KYOCERA Service Bulletin

SB Number:	SB 2BG-020	Creation Date: 17/12/2008
Subject:	Broken edge of the guide TC F	
Model:	KM-C2630/2630D

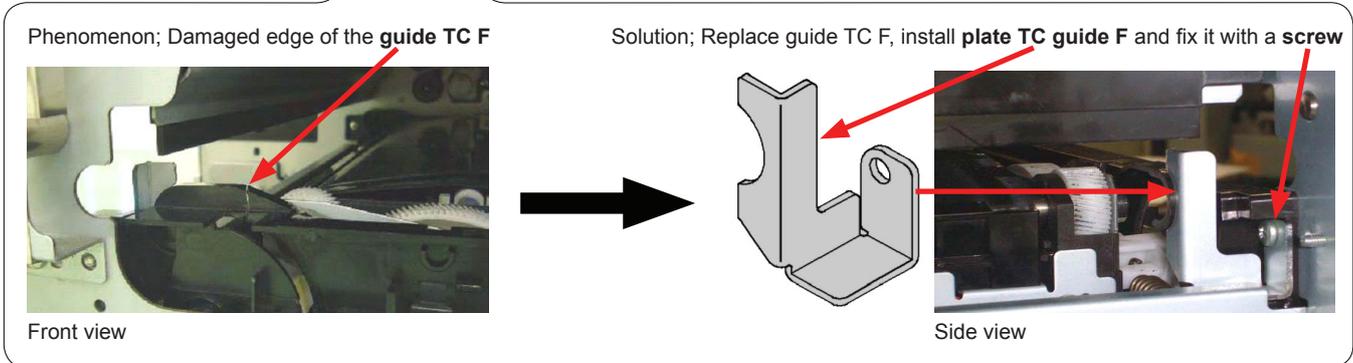
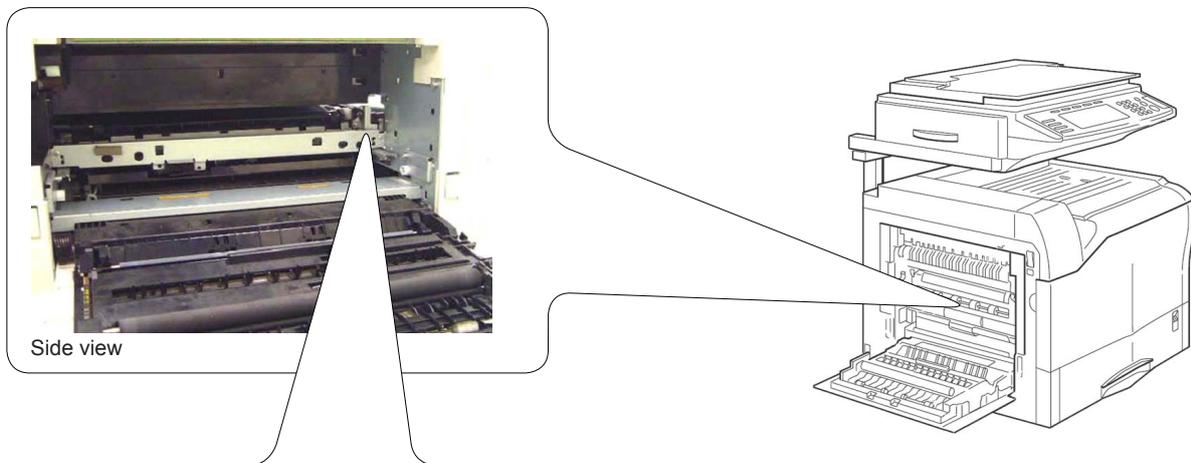
Phenomenon	The edge of the guide TC F 2BG02600 at the front of the machine may get cracked or brake off. Even when the edge of the guide TC F brakes of, it is unlikely it will cause a problem. However in rare cases image failure or paper jam may occur.
-------------------	--

Solution	Install plate TC guide F 302BG68580 to strengthen the edge of the guide TC F.
-----------------	---

Classification	<input type="checkbox"/> Entire stock rework	<input checked="" type="checkbox"/> In-field modification at next visit	<input type="checkbox"/> In-field modification by case	<input type="checkbox"/> No modification necessary
Field measure	When the above mentioned phenomenon occurs, please replace the guide TC F and install plate TC guide F.
